Access Compliance Report

Public Rights-of-Way

(Curb Ramps)

Intersection ID: 50586	Main Street: LONGSTRAW_RD	Cross Street: DOWNY_BIRCH_RD	Location: SE
ADA ID: F27CA021DE72	Ramp Type: Perp	Initial Pass/Fail: Fail	Overall Compliance: No
Severity Score: 10			
Codes/Mitigation Info/Possible Solution		Field Measurements/Component Compliance

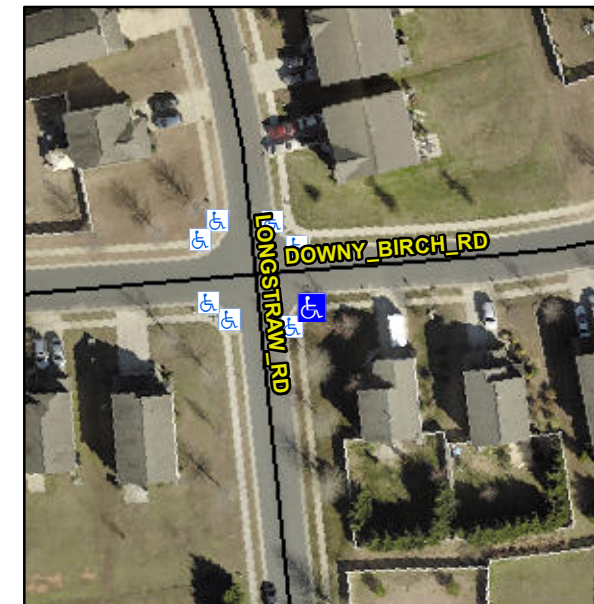
Not Found, R304.5.1, R304.5.3

Compliance	Description	Data	Compliance	Description	Data
N/A	Ramp Length (in)	48.0	Yes	Ramp Slope (%)	7.2
No	Ramp Width (in)	47.0	No	Ramp XSlope (%)	4.9
N/A	Flare Type LT	N/A	N/A	Flare Type RT	N/A
N/A	Flare Slope LT (%)	N/A	N/A	Flare Slope RT (%)	N/A
N/A	Flare Traversable LT?	N/A	N/A	Flare Traversable RT?	N/A
N/A	Landing Length (in)	N/A	N/A	DWS Provided?	N/A
N/A	Landing Width (in)	N/A	N/A	DWS Contrast?	N/A
N/A	Landing Slope (%)	N/A	N/A	DWS Length (in)	N/A
N/A	Landing X Slope (%)	N/A	N/A	DWS Full Width?	N/A
N/A	Landing Curb? (Y/N)	N/A	N/A	DWS Offset (in)	N/A
N/A	Shared Landing?	N/A			
N/A	Gutter Ponding?	N/A	N/A	Gutter Slope (%)	N/A
N/A	Gutter Lip Ht (in)	N/A	N/A	Gutter X Slope (%)	N/A
N/A	Painted X Walk1?	No	N/A	Painted X Walk2?	N/A
	X Walk 1 Direction	To N		X Walk 2 Direction	N/A
N/A	X Walk 1 Width (in)	N/A	N/A	X Walk 2 Width (in)	N/A
	X Walk 1 Slope (%)	1.5		X Walk 2 Slope (%)	N/A
	X Walk 1 X Slope (%)	4.1		X Walk 2 X Slope (%)	N/A

Remove & Replace Entire Ramp.
